SUBJECT: NuScale Power, LLC Supplemental Response to NRC Request for Additional Information No. 457 (eRAI No. 9501) on the NuScale Design Certification Application

NuScale Supplemental Response to NRC Request for Additional Information eRAI No. 9501

eRAI No.: 9501

NRC Question No.: 15-12

Figure 4.4-9: Analytical Design Operating Limits

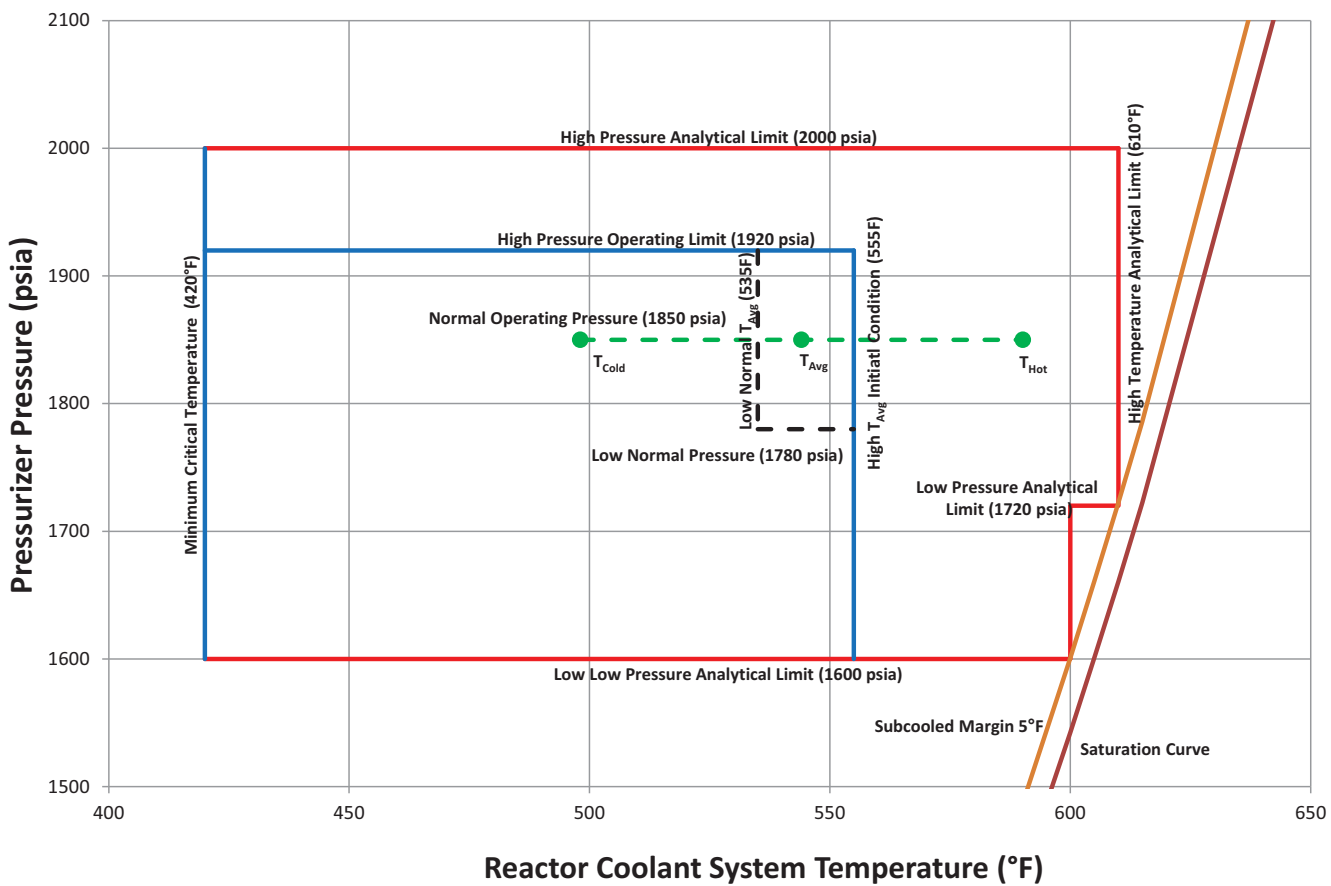
2. In addition, the staff is seeking clarification regarding FSAR Figure 4.4-9, "Analytical Operating Limits". FSAR Section 4.4.3.2, "Operating Restrictions", states that, "Figure 4.4-9 provides the operating map indicating the permissible operating range that is constrained by each of the following considerations." The staff interprets Figure 4.4-9 as defining the transient operating space (i.e., upset conditions a reactor enters during an AOO) as determined by the trip setpoints and not the initial permissible operating range for planned normal operation, which would be governed by Technical Specification LCOs. The staff is requesting that NuScale provide additional information regarding Figure 4.4-9 and revise the FSAR, if necessary, to clarify its intent.
-

FSAR Tier 2, Section 4.4.3.2 and Figure 4.4-9 have been modified to better reflect the operating and analytical design restrictions. Additionally, the Applicable Safety Analyses section of the bases of technical specification LCO 3.4.1 have been modified to better reflect the safety analyses related to the limits in this LCO.

~~Figure 4.4-9 provides the operating map indicating the permissible operating range that is constrained by each of the following considerations:~~ Figure 4.4-9 provides the operating map showing analytical and normal operating conditions. The green dotted line with T_{cold} , T_{avg} , and T_{hot} identified represent nominal full power operating conditions. T_{avg} remains fixed above 15 percent rated thermal power (RTP); T_{cold} and T_{hot} vary along the green dotted line as power is increased or decreased. The solid blue and black dotted lines illustrate the normal T_{avg} and RCS pressure operating ranges, excluding the T_{avg} during startup with the reactor at less than 15 percent RTP.

The analytical limits on the operating range that are illustrated as the outer box (red on three sides, blue at minimum critical temperature) constrained by the following considerations:

- ~~Right hand limit: core power and inlet temperature for given pressures that result in MCHFR at the CHF analysis limit~~ Upper RCS pressure bound: analytical limit protects against exceeding RPV pressure limits for reactivity and heatup events

- ~~Upperbound: analytical limit protects against exceeding RPV pressure limits for reactivity and heatup events~~ Lower RCS pressure bound: analytical limit ensures riser subcooling is maintained.
- ~~Left-hand boundary: analytical limit on minimum temperature for criticality~~ Left-hand temperature boundary: analytical limit on minimum temperature for criticality
- Right-hand average temperature limit: analytical riser temperature limit protects against exceeding MCHFR limits for reactivity and heatup events.

~~The low-RCS pressure analytical limit ensures riser subcooling is maintained. If hot leg temperature is below 600 degrees F, the low pressure analytical limit is constant at 1600 psia. If hot leg temperature is above 600 degrees F, then the low pressure analytical limit increases as:~~ If hot leg temperature is below 600 degrees F, the low pressure analytical limit is constant at 1600 psia. If hot leg temperature is above 600 degrees F, then the low pressure analytical limit increases to 1720 psia. The saturation curve and a parallel, 5 degrees F margin are illustrated on the right side of the figure showing the margin to saturation in the riser based on the analytical limits shown.
